Office Action Summary

10/730,852

OYU ET AL.

DETAILED ACTION

Fig. 2 PRIOR ART

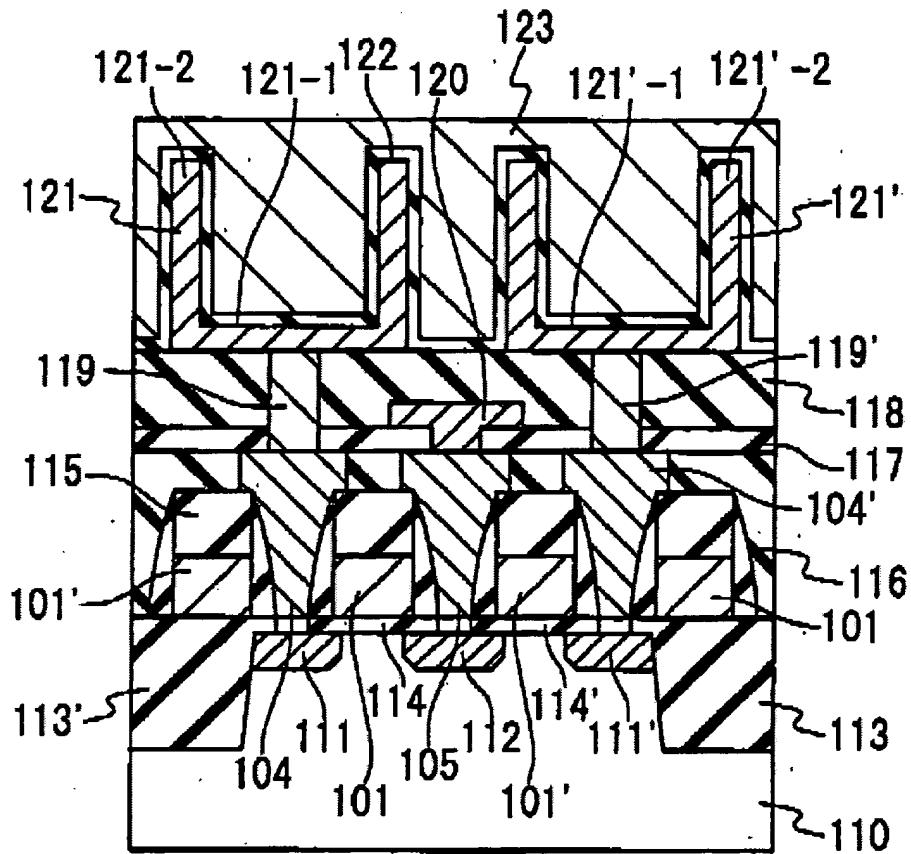
The AAPA (as shown in fig 1, fig 2, the background section of the application 0 discloses all the invention except is silent about the gate length that is longer than the processing dimension. Bronner, however (column 2 lines 52-53) discloses that a gate length longer than the processing dimension can be use to cure a leakage problem in DRAM.

Fig. 5

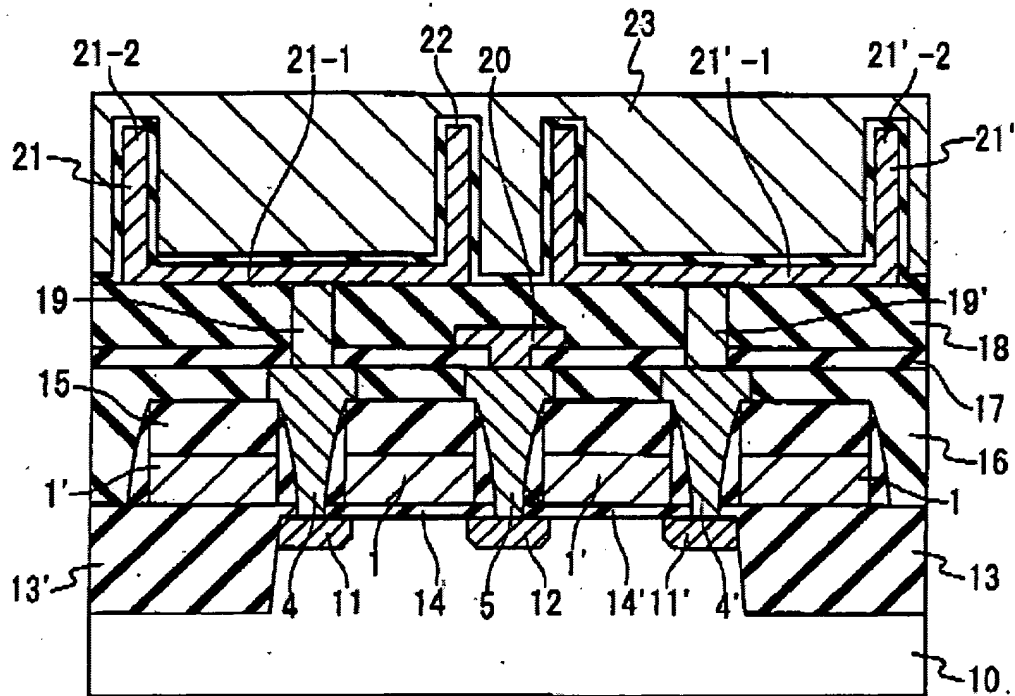
APPLICANT'S INVENTION

The combined teachings by the AAPA and Bronner disclose all the invention except for the side length of the first contact and the second contact. These features, however, are considered obvious since it has been held that when the general condition of a claim are
